SUBJECT: NuScale Power, LLC Response to NRC Request for Additional Information No. 281 (eRAI No. 9082) on the NuScale Design Certification Application

NuScale Response to NRC Request for Additional Information eRAI No. 9082

eRAI No.: 9082

Figure 5.4-16: Primary Coolant Temperature Cooldown with Decay Heat Removal System One Train Operation: High System Inventory, 140°F Initial Pool Temperature - 36 Hours

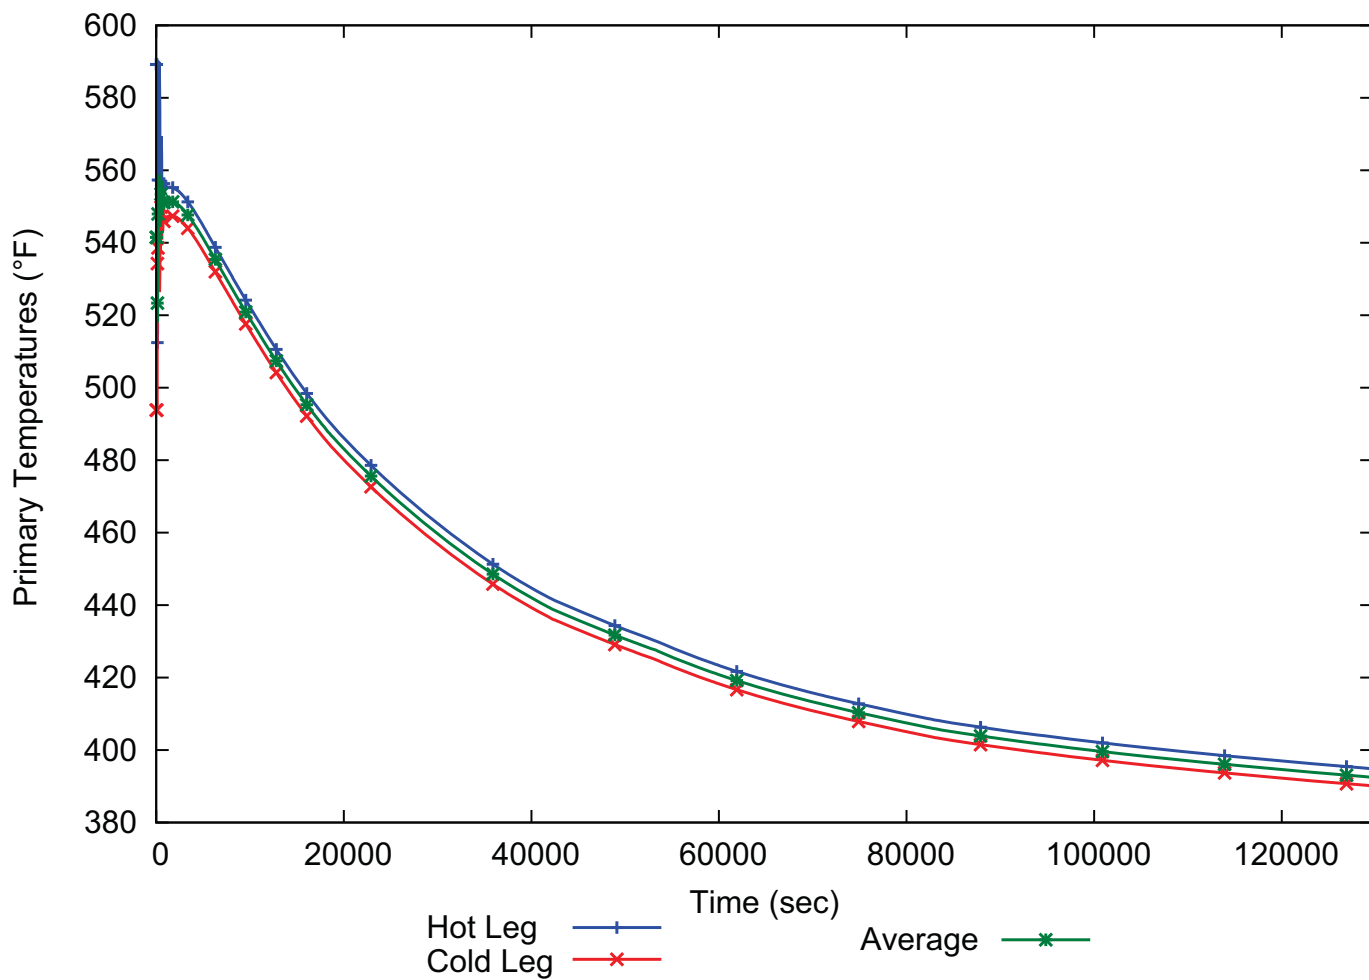
In reviewing the NuScale detailed design documentation during an audit, staff discovered that the initial reactor pool conditions for the cases referred to in the FSAR (Figures 5.4-11 through 5.4-15) were 100F, rather than 140F (the maximum allowed reactor pool value in technical specifications). In FSAR section 5.4.3.3.4, these analyses are referred to as “assuming limiting off-normal conditions”. This statement aligns with the staff’s understanding that the single-train analyses documented are intended to represent bounding analyses for the DHRS performance. Although staff recognizes that NuScale has performed sensitivity studies that demonstrate the DHRS performance for higher reactor pool temperatures, these cases are currently not reflected in the licensing basis documentation. Staff requests that NuScale clarify the description of the limiting DHRS performance in the FSAR by either revising the calculations presented there or adding additional discussion related to the sensitivity cases and characterizing the effect of any conditions that were non-limiting in the cases presented in the FSAR.

The analyses in FSAR Section 5.4.3.3.4 are provided as the performance evaluation for the decay heat removal system (DHRS) consistent with Reg. Guide 1.206, Section C.I.5.4.7.3. The off-normal transient cases presented in FSAR Section 5.4.3.3.4 are intended to use initial conditions that are consistent with the DHRS design basis and provide the most limiting conditions for evaluating the ability of the DHRS to cool the reactor coolant system (RCS) to below 420°F in 36 hours. As identified in the question, the pool temperature of 100°F is not the most limiting for DHRS thermal performance.

FSAR Section 5.4.3.3.4 has been updated to include an off-normal high inventory case with an initial reactor pool temperature of 140°F. A pool temperature of 140°F is consistent with the upper temperature limit of Section 3.5.3 of the Technical Specifications. The results of this additional case are marginally more limiting when compared to the 100°F initial reactor pool temperature case in FSAR Figures 5.4-14 and 5.4-15. The average RCS temperature after 36 hours is 391°F for the 100°F initial pool temperature case and 392°F for the 140°F initial pool temperature case.
